SERVICE BULLETIN

TS-940S AGC CIRCUIT IMPROVEMENTS

6-03-86

RF Unit

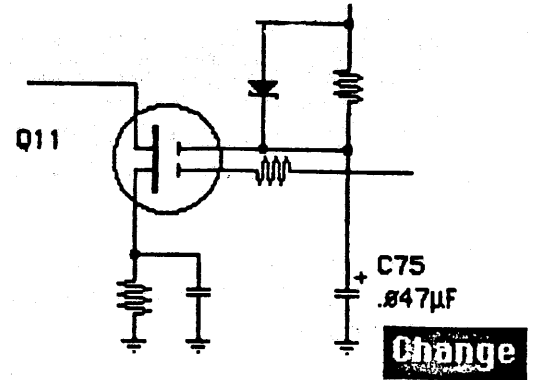
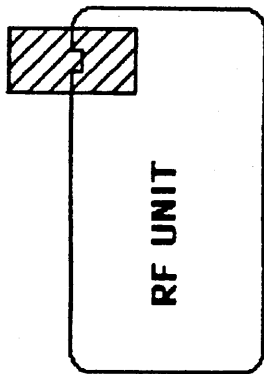
RF UNIT

1. Remove jumper wire JP7 and replace it with the parallel combination of the 15 k ohm resistor and the 1S1555 diode. Pay close attention to polarity.
2. Add the 1 uF capacitor as shown in the diagram.

IF Unit

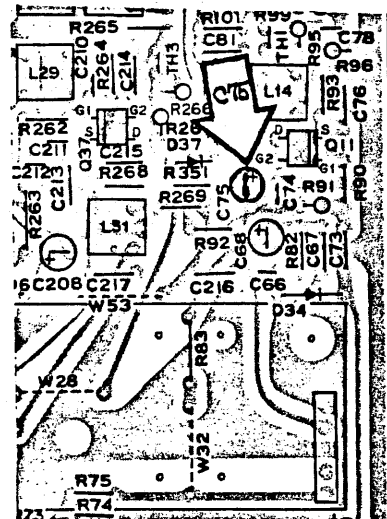
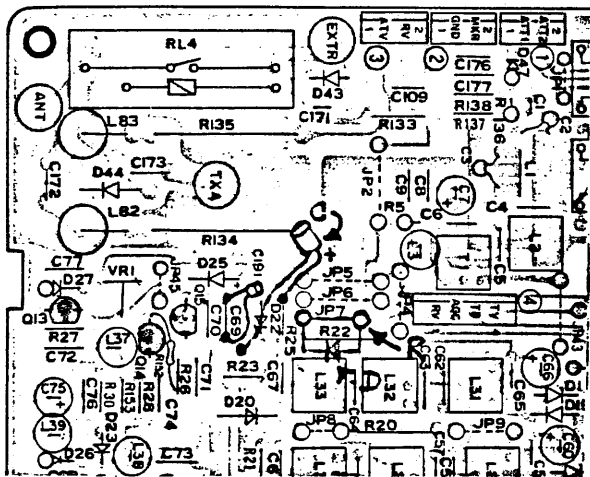
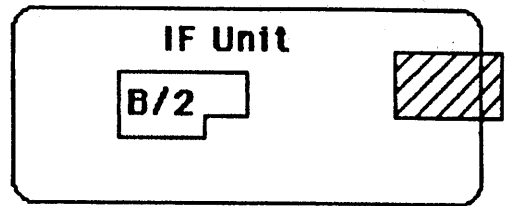
IF UNIT

Change capacitor C75 from a 1 uF 50 v capacitor to a .047 uF 50v capacitor.
